Project: 925 S. Tamiami Trail Monument Sign
Site and Development Plan Amendment Petition No. 17-11SP

Staff Report

Summary of Site and Development Plan Amendment:

Figure 1: Proposed Monument Sign

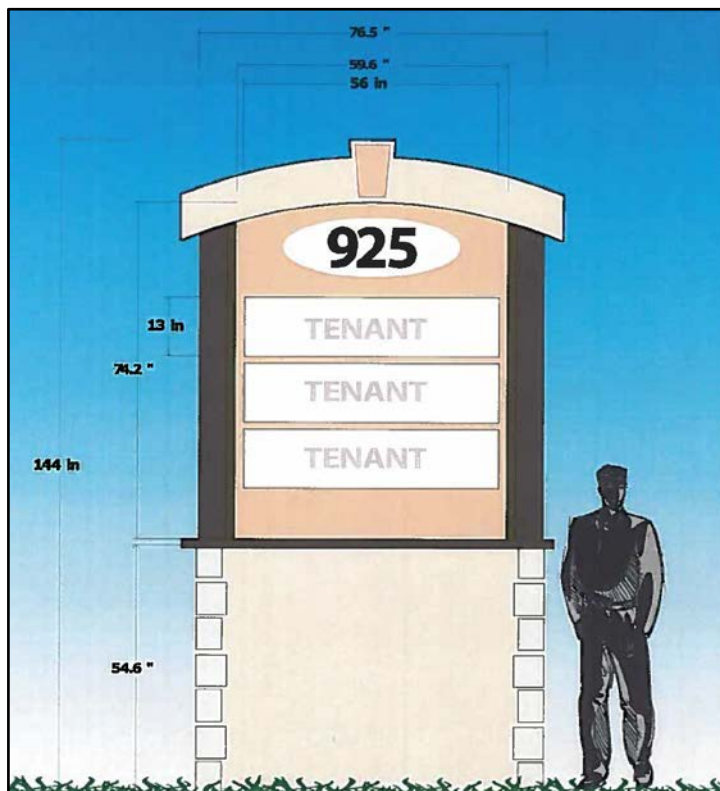
The proposed monument sign complies with each of the above sign standards. The proposed sign complies with the monument design standard which requires a base, cap and column design. In addition, the sign has been designed to incorporate the following design features of the building on the site:

- The cap of the monument sign replicates the design element over the second story windows,
- The sides of the monument sign base replicate the design element of the front corners of the building, and
- The monument sign colors compliment the colors of the building.

Staff Comment: *The proposed monument sign complies with all applicable sign code standards and is designed to be less than the maximum allowed sign height and area. The maximum sign height is 15 feet and the proposed sign has a height of 12 feet; the proposed 77 square foot sign structure is nearly half the maximum allowed area of 150 square feet. If the subject petition is approved, an obsolete, non-conforming pylon ground sign will be removed from the site.*

Figure 2: Location of Proposed Sign

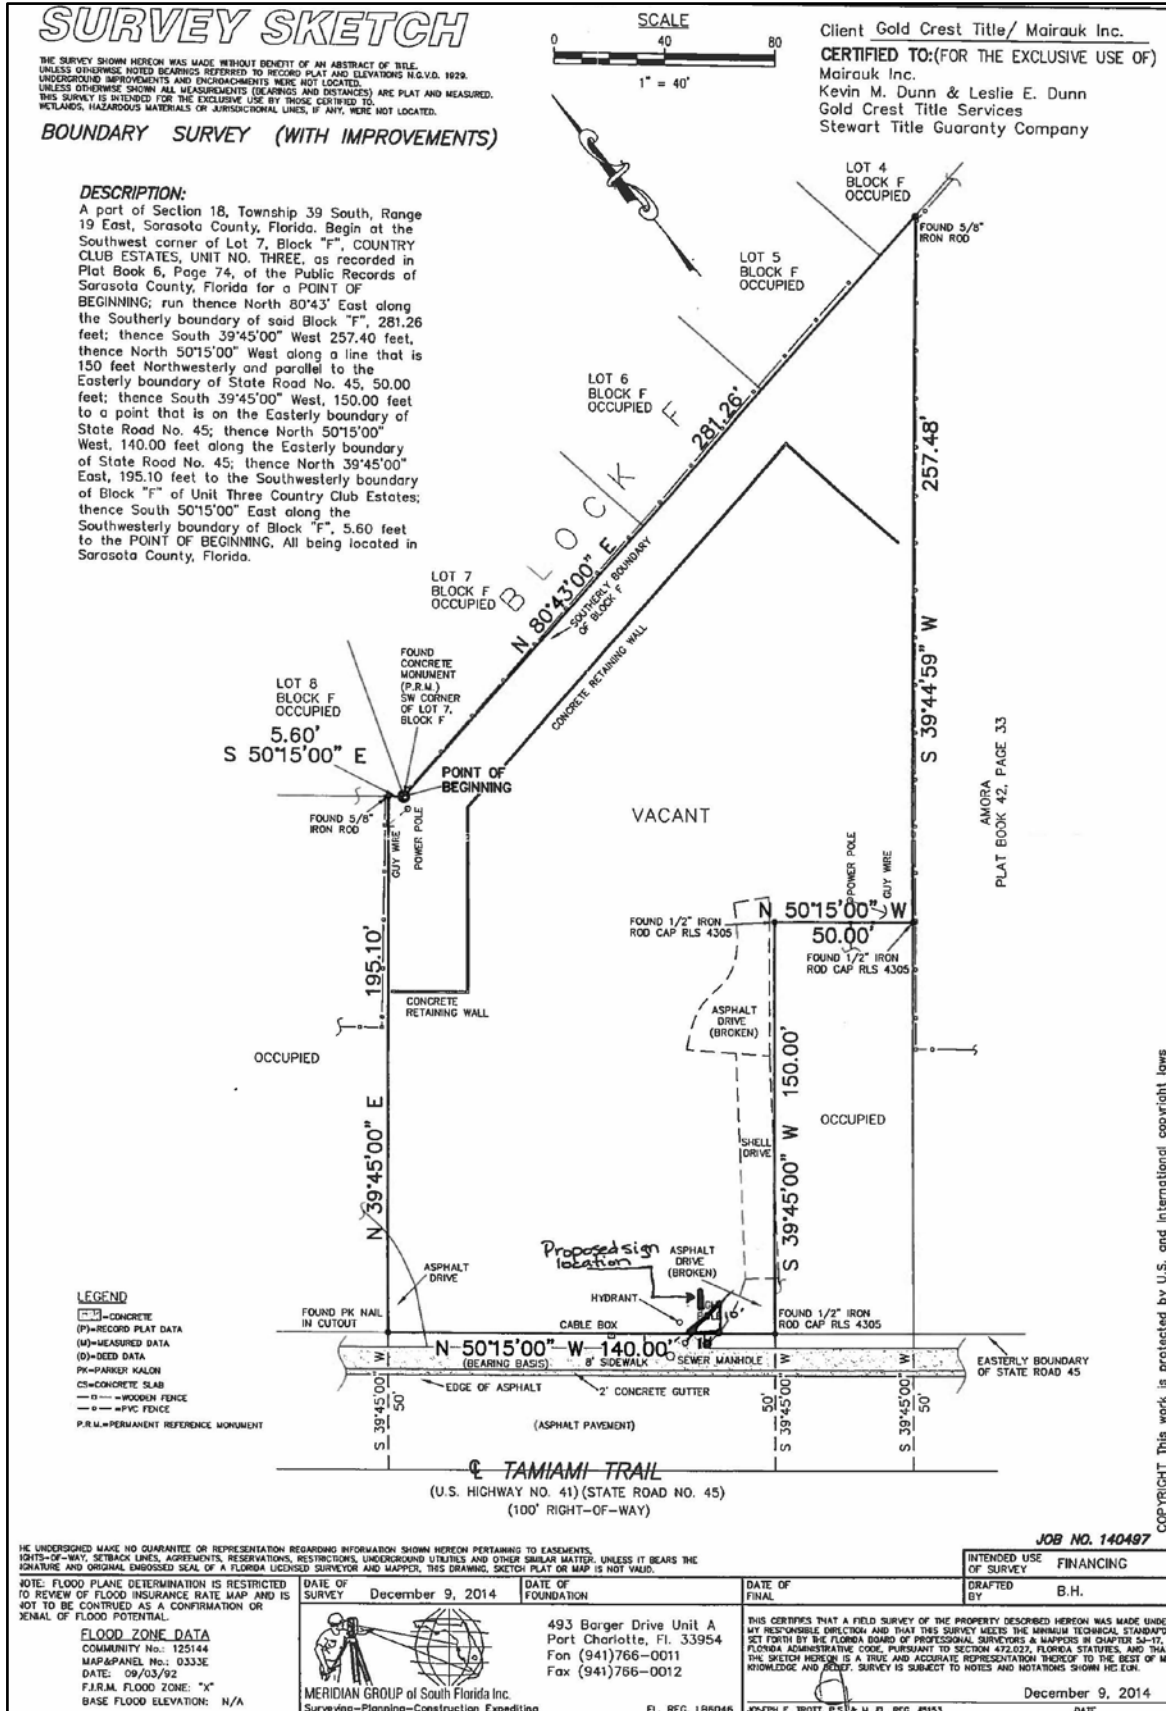
Staff Comment: *The proposed monument sign will not impact ingress and egress to the subject property. The sign is outside the required ten-foot visibility triangle at the driveway intersection with U.S. 41 Business and the sign complies with all applicable setback requirements. The Technical Review Committee (TRC) review did not identify concerns regarding automotive and pedestrian safety, servicing of utilities, refuse collection and emergency access to the property.*

The existing pylon ground sign structure shall be removed prior to the issuance of any permit for the proposed monument sign.

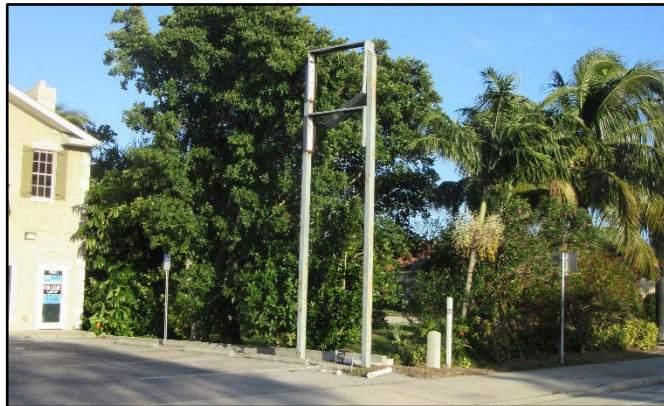
Existing pylon sign structure that will need to be removed prior to the issuance of a sign permit for the new monument sign.

Stipulation: *The existing pylon ground sign structure shall be removed prior to the issuance of any permit for the proposed monument sign.*
